**RE: SCS Carbon Transport LLC
Midwest Carbon Express Project
Case No. PU-22-391**

**RE: Case No. PU-22-391
SCS Carbon Transport LLC
Midwest Carbon Express Project**

BUOYANCY CONTROL STUDY

**Figure 2: Safety Factor determined by Saturated
Density of Backfill**

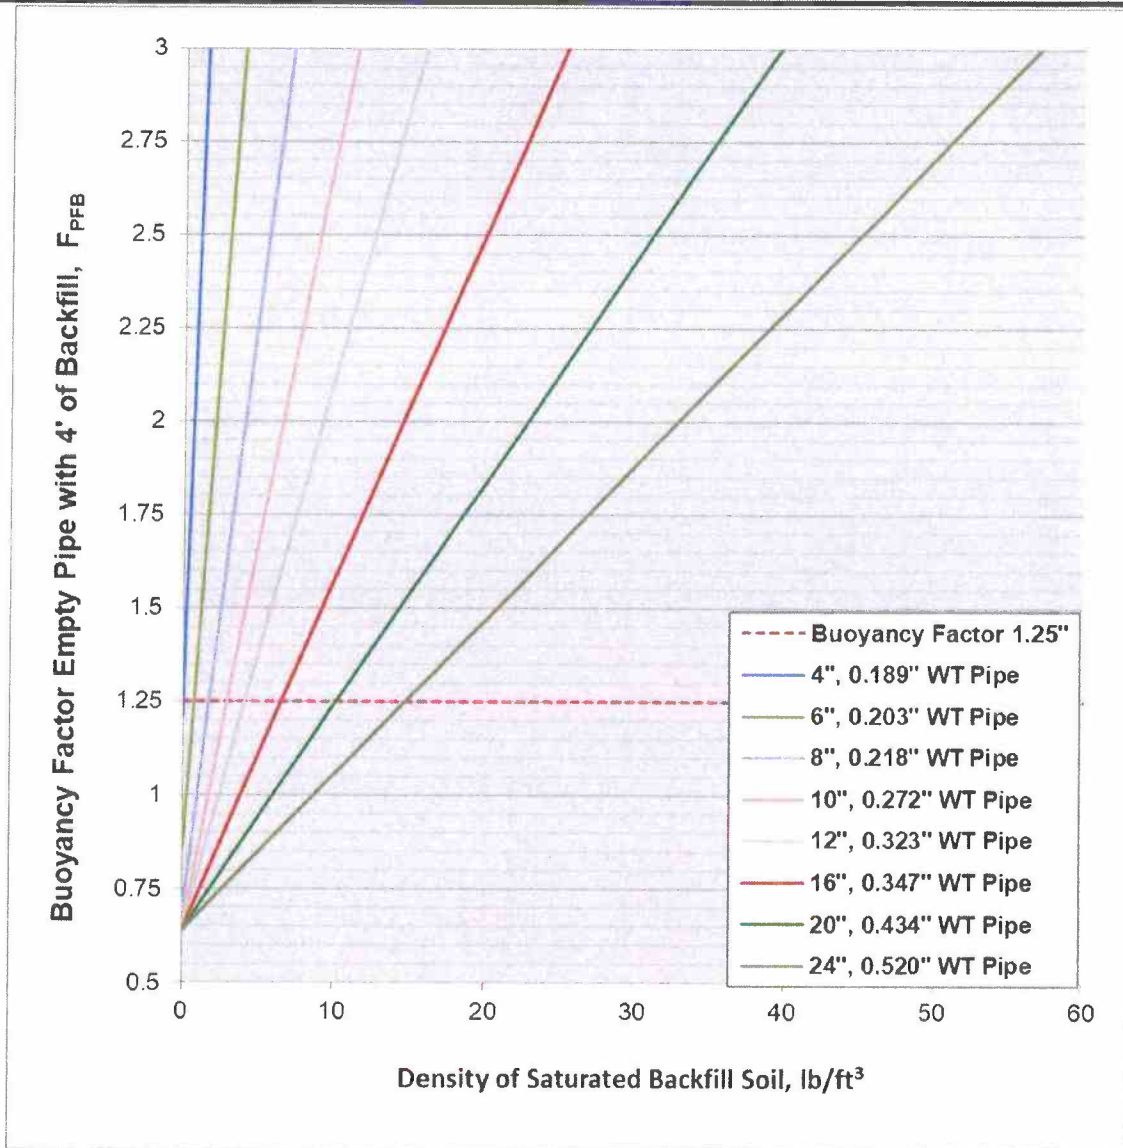
6. *What is buoyancy and is it a concern with respect to pipelines in North Dakota, including SCS's proposed carbon dioxide pipeline?*

A summary of calculations for all pipe diameters at various soil densities can be found in Appendix 1. Results are also graphically represented in Figure 4, where areas above the red dotted line exceed the required 1.25 safety factor and do not require additional buoyancy controls measures.

To assess the risk of buoyancy, the soil cohesion as well as density were evaluated based upon a wide range of soil types. Based on the results of the soil categorization, only Type C soils may require buoyancy control. The next soil property to evaluate is density. The density of backfill necessary to meet a 1.25 safety factor increases with pipe size. To meet a safety factor of 1.25 for all pipe diameters on the project the soil must have a minimum density of 15 lb/ft³, as shown in Figure 2. Comparing the soil density values across the entire route to the calculations, there are no identified locations that will require buoyancy control. There may be weather conditions that do not allow for the dewatering of the pipeline trench, in these instances, additional buoyancy control measures such as Geotextile Pipeline Weights (GPW) will be deployed.

EXHIBIT C

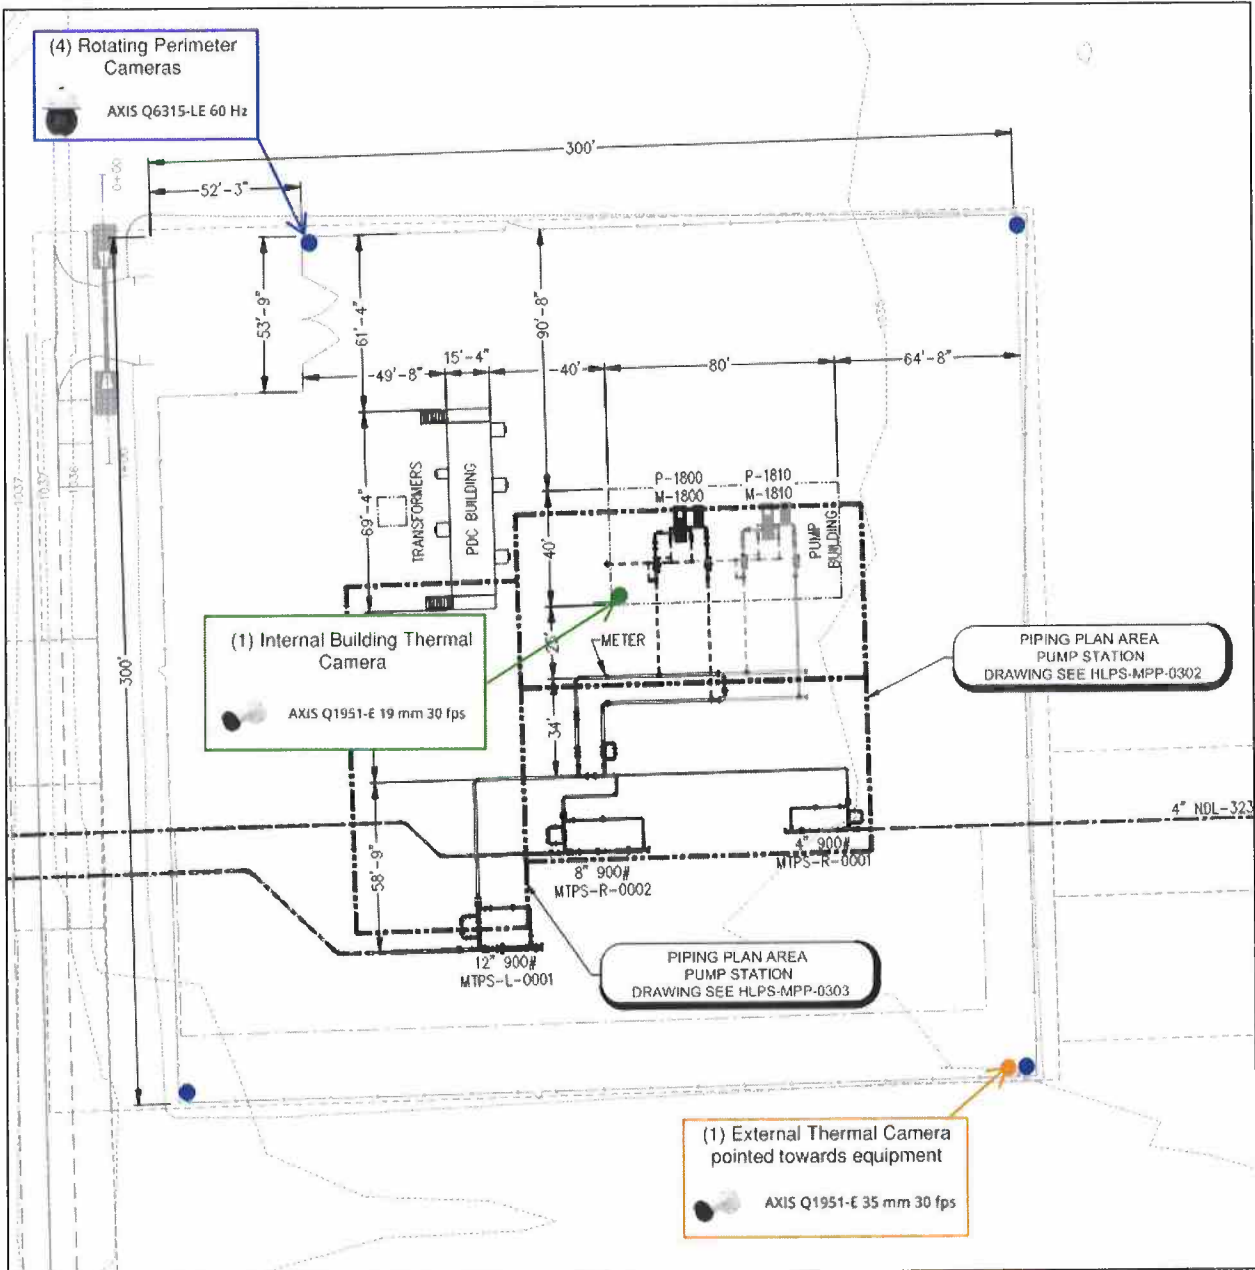
11. *Will SCS install security cameras at each pump station location?*

RESPONSE: Yes. See Exhibit C attached hereto.
